SUBJECT: TECHNICAL REVIEW: SALTSTONE WASTE FORM HYDRAULIC
PERFORMANCE, DOCKET NO. PROJ0734

Technical Review of Saltstone Waste Form Hydraulic Performance

Date March, 2017

Figure 1. Feed Rates for Saltstone Processed on 8/12/2013 (reproduced from Figure 5.1 in SRR-CWDA-2016-00051)

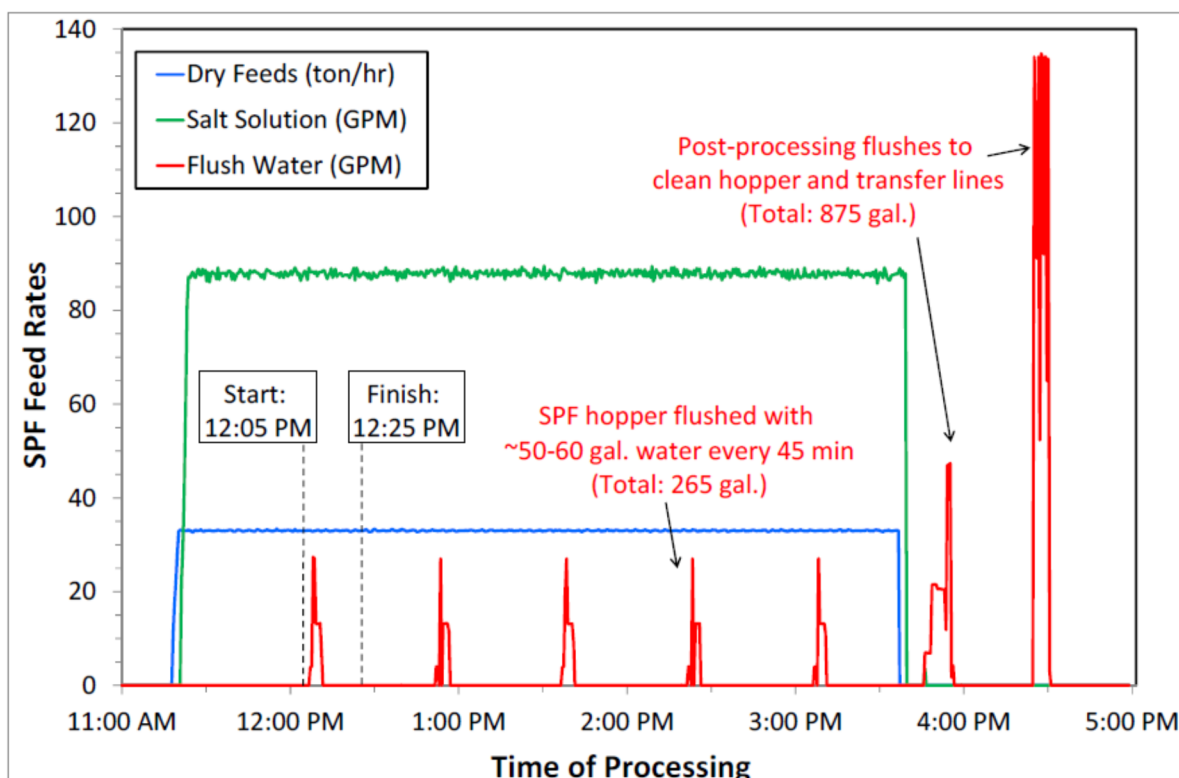
In addition, the DOE analyzed water additions to the SPF hopper and mixer as well as subsequent withdrawals of water from the drain system. From that analysis, the DOE determined that during the time period analyzed, which covered two production days, a total of 3,810 gallons was added to the hopper and mixer (combined), of which 2,160 gallons (56%) remained in the disposal structure and 1,650 gallons (44%) exited through the drain system. The data do not differentiate between the water added during processing and the larger volume of water added at the end of the day of processing.

The DOE also provided data showing that an increase in liquid-to-premix ratio from 0.59 to 0.73 appeared to cause: (1) increased saltstone porosity (from 63.8 to 66.1) and (2) increased hydraulic conductivity (from 2.9×10^{-9} cm/s to 8.5×10^{-9} cm/s) (SRR-CWDA-2014-00099). However, the DOE did not present evidence that the liquid-to-premix ratio in emplaced saltstone would be limited to 0.73. As shown in Figure 2 below, the DOE expected flush water to cause temporary excursions of the liquid-to-premix ratio that could be significantly greater than 0.73. Although Figure 2 below shows excursions as high as 1.8, the limit of the liquid-to-premix ratios in emplaced saltstone is expected to be less than that value because a significant fraction of the flush water is removed through the drain system instead of being incorporated into saltstone. The precise values are not known because, although the DOE understands generally how much flush water is incorporated into saltstone from analyzing flush water additions and water removed from the drainage system, it is unclear how much saltstone the water is incorporated into.

Figure 2. DOE estimated upper bounds of liquid-to-premix ratio during several days of processing including the effects of flush-water additions (reproduced from Figure 4.2-2 in the FY 2013 Special Analysis document).

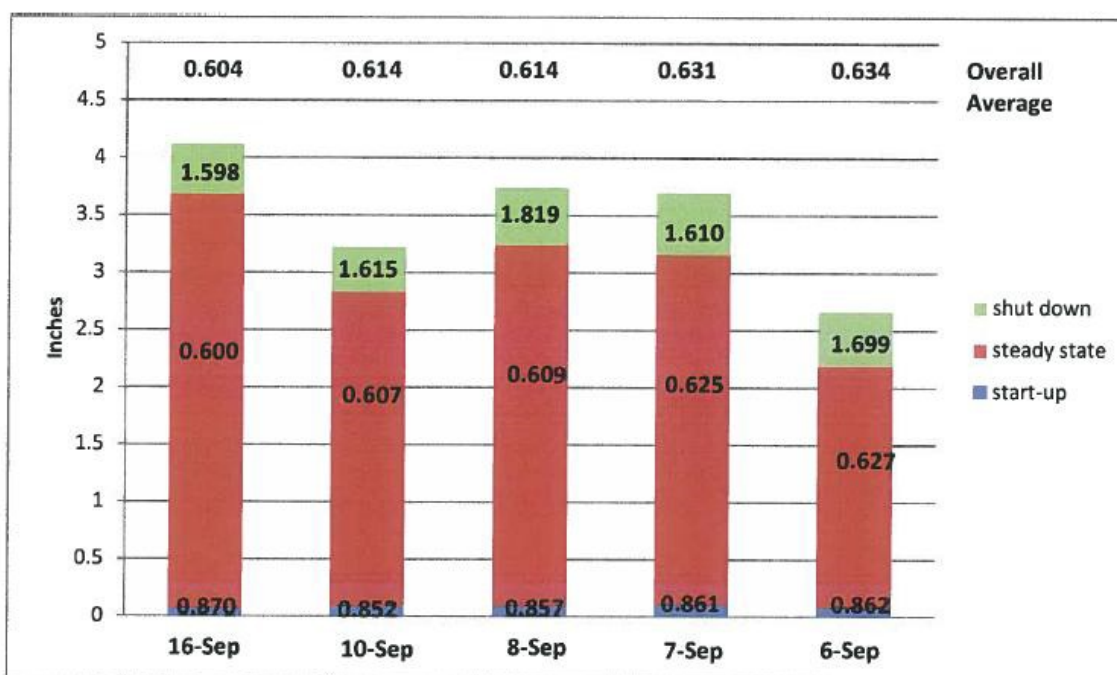
Some evidence of the effects of flush water additions on saltstone properties is provided by data from the core samples taken from SDS 2A. In recent reports (SRR-CWDA-2016-00051; SRNL-STI-2016-00106), the DOE compared three types of samples that had different flush-water additions: (1) samples made in the laboratory with simulated salt waste (see Table 1, Set 3 above), (2) samples processed in the field and cured in the laboratory (see Table 1, Set 8 above), and (3) cores from emplaced saltstone (see Table 1, Set 9 above). Samples made in the laboratory (see Table 1, Set 3 above) contain no flush water. For samples processed in the field and cured in the laboratory (see Table 1, Set 8 above), two samples were taken. The dashed vertical lines in Figure 1 above show the window in which the samples were taken relative to the flush water additions. However, in the report SRR-CWDA-2016-00051, the DOE indicated that it was unclear precisely when during the sampling window the two samples were

Figure 3. DOE plan for cutting sub-samples from the SDS 2A cores. The DOE indicated that section lengths were approximated and based on estimated depths of daily pours to SDS 2A between August 11-16, 2013 (from Figure 2-1 in SRNL-STI-2016-00106).

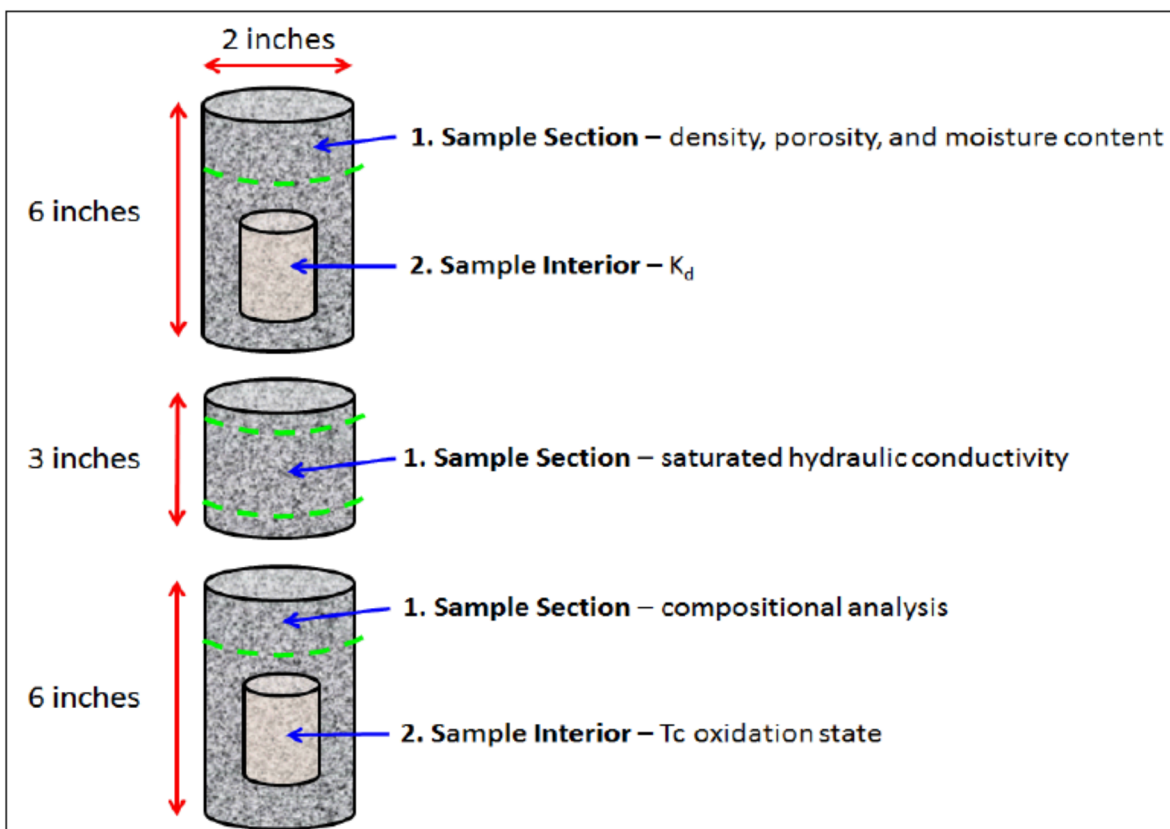
Saturated hydraulic conductivity measurements were taken of samples cut from core interiors (see Figure 3 below) to avoid artifacts of core drilling. That approach was necessary because of the difficulty of field-drilling cores. The DOE indicated that, although the density and porosity of the SDS 2A core samples varied from the density and porosity of the laboratory-prepared samples, the difference was not of practical importance because there was not a significant difference between the measured saturated hydraulic conductivities of the SDS 2A cores and that of laboratory-prepared samples. That could occur if the samples' densities and porosities did not change enough to significantly affect the saturated hydraulic conductivity. Another possible explanation could be that, because many of the samples had a hydraulic conductivity below the detection limit, the experiment could not detect the difference between the SDS 2A cores and laboratory-prepared samples. A third possible explanation could be that, because the density and porosity were measured in sub-samples taken from the sample ends and the

saturated hydraulic conductivity was measured in sub-samples taken from sample interiors, the density and porosity measurements reflected the effects of flush-water addition while the saturated hydraulic conductivity measurements did not.

Figure 4. Comparison of moisture characteristic curves from the 2009 PA and FY 2014 Special Analysis document.

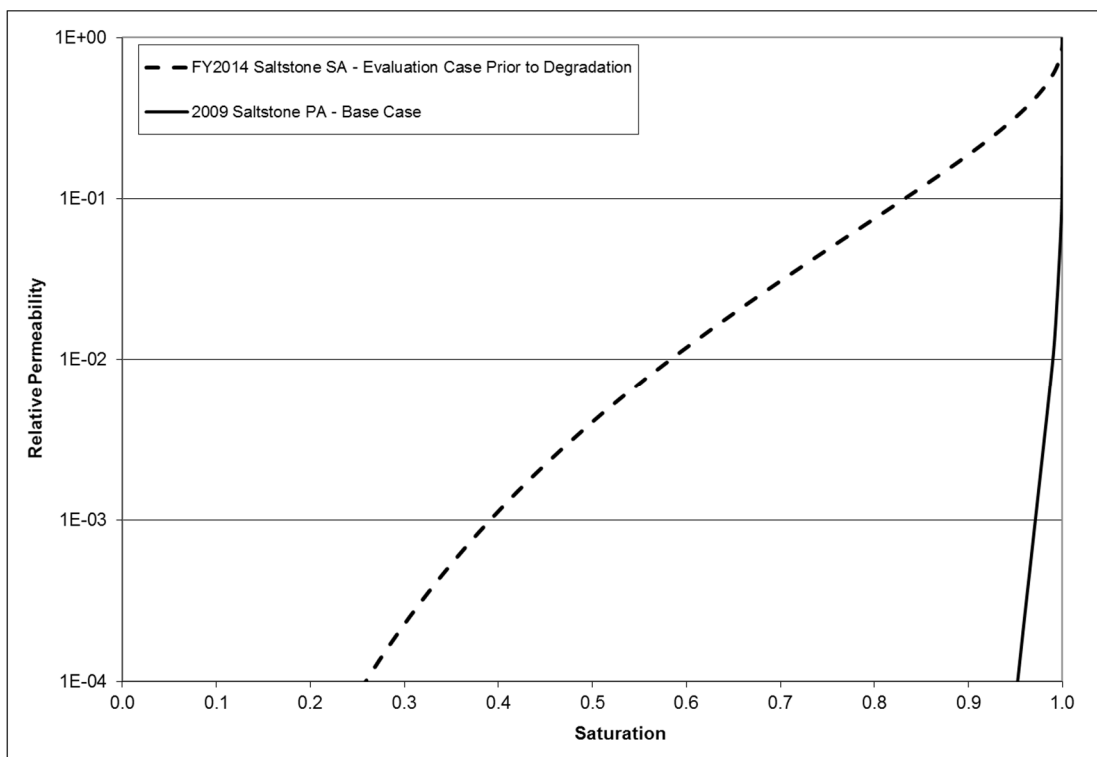
In the 2012 SDF TER, the NRC raised concerns related to the DOE assumed MCCs in the 2009 PA Base Case. However, in Case K in the 2009 PA RAI comment responses (SRR-CWDA-2011-00044, Rev.1), the DOE revised the approach to unsaturated flow through saltstone and assumed that the relative permeability was 1.0 independent of saltstone saturation (i.e., the DOE assumed a MCC that did not diminish the hydraulic conductivity from the saturated hydraulic conductivity). In both the FY 2013 and FY 2014 Special Analysis documents, the DOE included a revised MCC for saltstone that was not equal to 1.0 and which varied in time according to the assumed extent of degradation (SRR-CWDA-2014-00006). The NRC will address MCCs that were used to simulate saltstone degradation under *Monitoring Area 4 - Waste Form Physical Degradation* and disposal structure degradation under *Monitoring Area 6 - Disposal Structure Performance*. For all of the disposal structures described in the FY 2014 Special Analysis document, the initial MCC for saltstone grout (i.e., prior to saltstone degradation⁸) is shown in Figure 4 below. The relative permeability does not decrease as rapidly with saturation in the FY 2014 Special Analysis document as it did in the 2009 PA. The NRC determined that the risk significance of the MCC used in the FY 2014 Special Analysis document for saltstone grout prior to degradation is limited because of the high initial saturation of saltstone.

The DOE predicted that the saturation for saltstone grout prior to degradation for SDS 1, SDS 4, the 150-ft disposal structures, and the 375-ft disposal structures was always greater than 99.95%. At those saturation values, the assumed MCC designates that the relative permeability would be no less than 87% of the saturated hydraulic conductivity. That allowed the NRC to determine that the resultant relative permeability for saltstone grout prior to degradation is of limited risk significance. However, changes to assumptions in the modeling of saltstone could result in lower predicted saturation levels and consequently lower relative permeabilities, which could be risk significant. If the DOE relies on the same MCCs in future revisions to the PORFLOW model and the model predicts lower saturation levels prior to degradation, then the DOE may need to provide additional support for the assumed MCCs if the model results indicate a significant degree of risk reduction.
